Subject: RE: Rustington Convalescent Home - R/93/25/DOC

Subject: RE: Rustington Convalescent Home

4. We assume that Arun DC comment on the GW level of 3.03 m AOD refers to a water level observed in WS202? If that is the case then the interpretation seems to be incorrect as the GW observed is not at 3.03m AOD, it is at 3.03 m BGL (below ground level) which is 1.21m AOD – far below tank 4 base level. Based on GW monitoring any storage on site would not be compromised by GW levels and thus the resultant risk of flooding is mitigated. **Yes the comment was raised so the anomaly of a mid-site higher reading can be reviewed. On the basis this assessment is correct, then tank 4 would have sufficient freeboard and this comment would be resolved.**

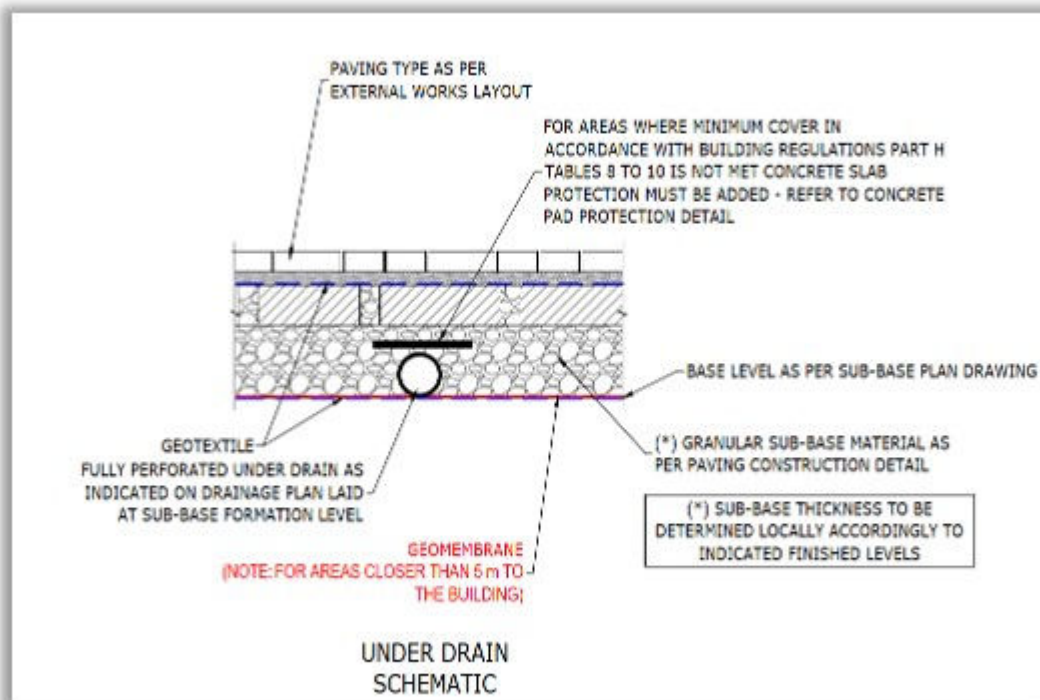
8. We presume that where Arun DC is discussing the "(GREEN)" pipes it means the underdrain pipe, and if that is the case the underdrain detail is already provided on drawing 25-043-111 (as per below snapshot) and underdrain maintenance access / manholes detail is provided on drawing 25-043-112. Underdrains were already part of our hydraulic modelling (as per the example snapshot below), therefore the comment *"...Furthermore the addition of these pipes may impact of the 1D modelling where run-off may be conveyed to lower areas quicker than intended."* was already addressed.

Project: 25-043 Rustington, Sea Road Rev A	Date: 05/08/2025 Designed by: AK	Checked by:	Approved By:
Report Details: Type: Stormwater Controls Storm Phase: Storm_RevA	Company Address: Odyssey Romsey

Porous Paving (7) Type : Porous Paving

Dimensions	
Exceedance Level (m)	3.950
Depth (m)	1.030
Base Level (m)	2.920
Paving Layer Depth (mm)	260
Membrane Percolation (m/hr)	1000.0
Porosity (%)	30
Length (m)	54.000
Long. Slope (1:X)	500.00
Width (m)	4.800
Total Volume (m³)	65.887

Under Drain	
Height Above Base (m)	0.000
Diameter (mm)	225
No. of Barrels	4
Release Height (m)	0.000
Friction Scheme	Colebrook-White Roughness
Roughness (mm)	0.6
